# State of Utah

DEPARTMENT OF COMMERCE  
Committee of Consumer Services

## CCS EXHIBIT 2.2

Subject: Recommendations of the Committee of Consumer Services Regarding  
Schedule 37: Avoided Cost Purchases from Qualifying Facilities up to 1 MW  
No. 03-035-T10

## Figure 1

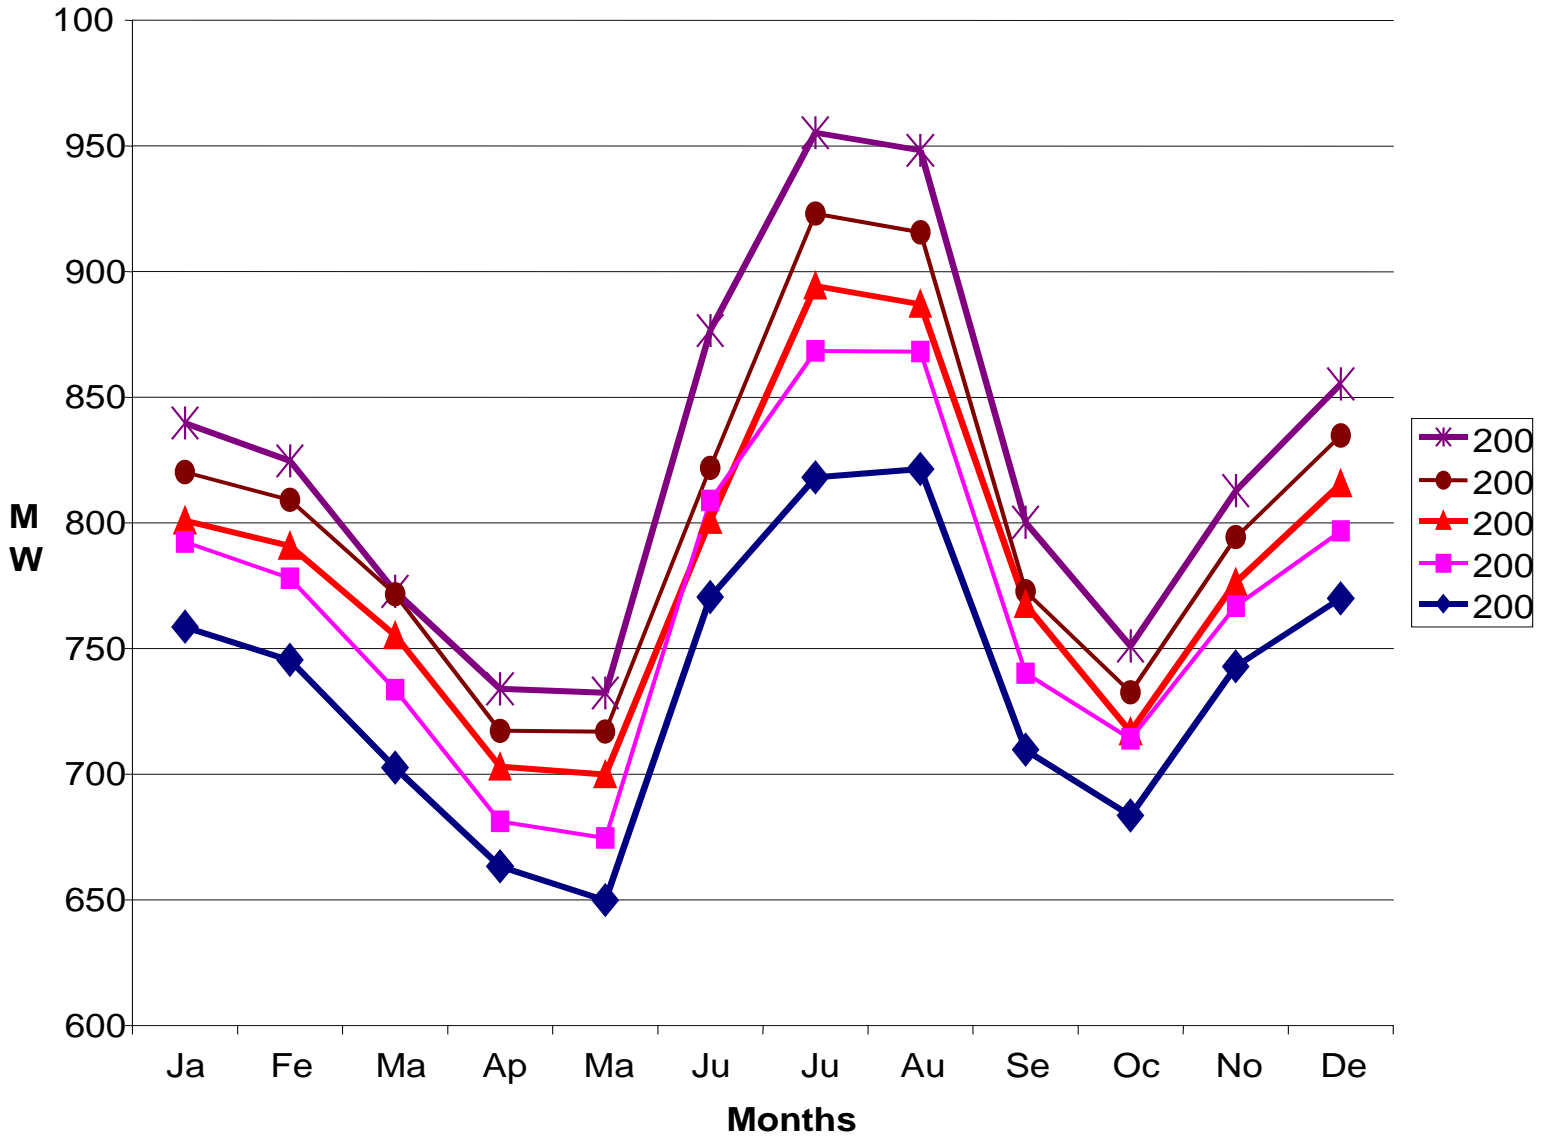
PacifiCorp defines its summer season to include the six-month period between May and October, and the winter season to include the remaining six months in the year, November through April. However, there doesn't appear to be any support for that seasonal definition when considering PacifiCorp's loads and costs. The summer period is usually the highest load period, and has the highest average costs in the year. By including both May and October in the summer period, PacifiCorp has included shoulder months that have more in common with the winter period than they have with the summer period. The impact on the avoided cost calculation is that the summer period avoided costs are lower than they should be, and the winter period avoided costs are higher than they should be.

Figure 1 shows the peak loads that PacifiCorp assumes for each month between 2004 and 2008. Figure 2 shows the monthly average system cost as computed using PacifiCorp's GRID model, which was used for the computation of the avoided costs. Each of these graphs show that the months of May and October are dissimilar compared to the other summer months and are more aligned with the winter months. Thus, in the calculation of summer avoided costs only the months of June through September should be included, while the remaining months should be included in the winter period.

- 2.1 The Committee recommends the Commission limit the definition of the summer period to June through September. PacifiCorp has defined this seasonal period as May through October, which distorts the true summer and winter periods, as well as the corresponding avoided costs.

**Figure 3**  
**PacifiCorp Monthly Deficiency**

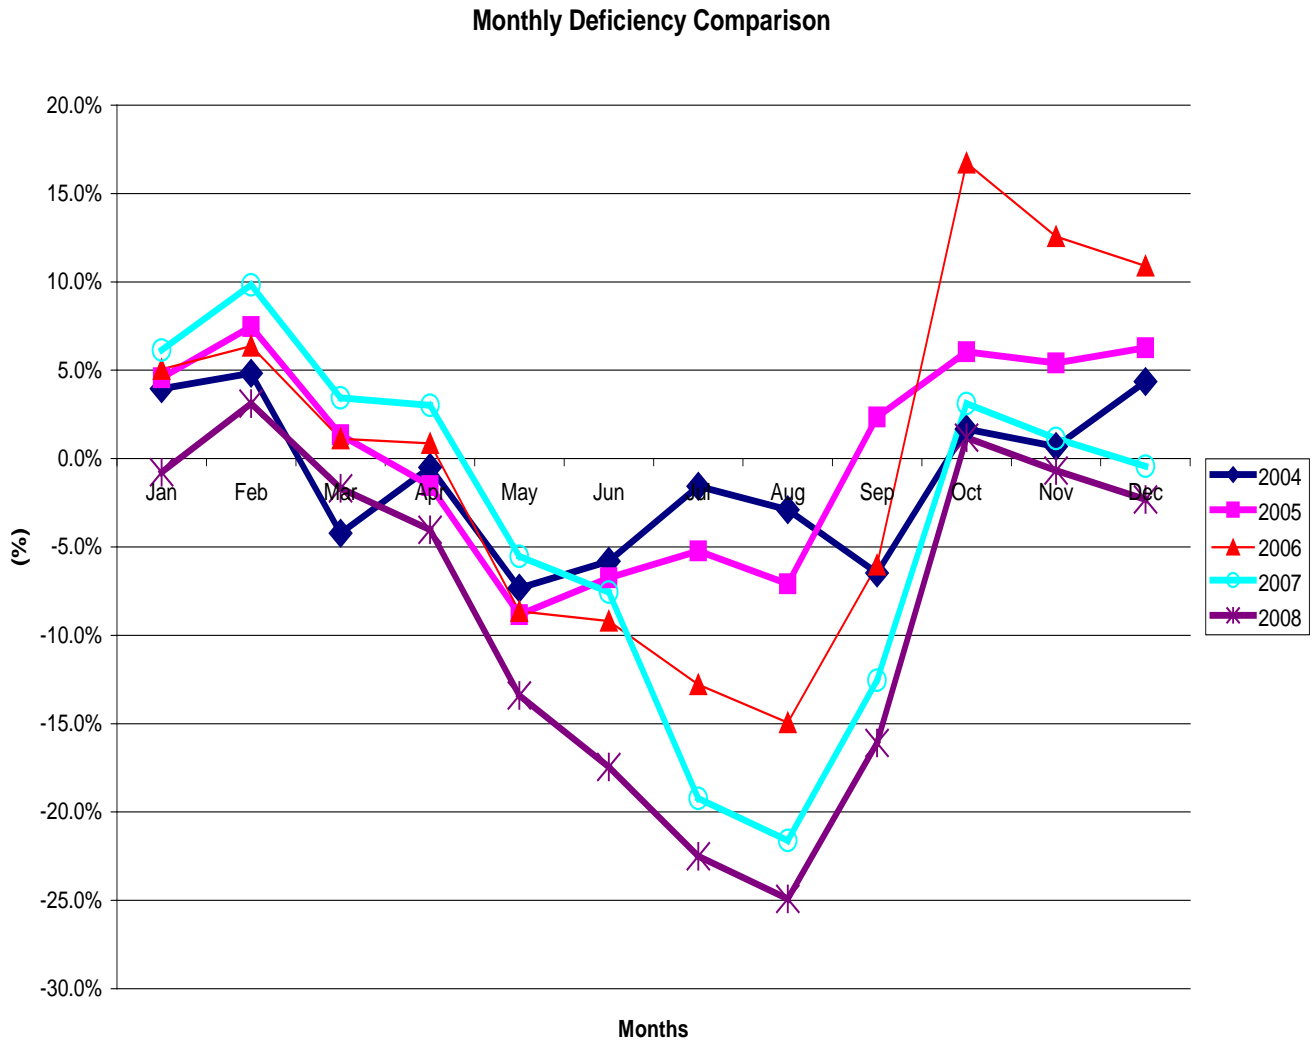
In examining the load and resource balance for all 12 months of the year, there are at least three additional months where the Company has a capacity deficiency. The following graph, Figure 3, compares the capacity deficiency for each month of each year between 2004 and 2008. Figure 3 illustrates that during the period of 2004 – 2006, the average number of months per year of a deficit condition is six. The Committee therefore recommends that the Commission require avoided cost capacity payments be made for at least six months of the year.

- 2.2 The Committee recommends the Commission expand the minimum number of months in which the avoided cost capacity payments should be made from three months to six months. The three months recommended by PacifiCorp does not comport with the number of months it is capacity deficient and thus requires additional capacity resources.
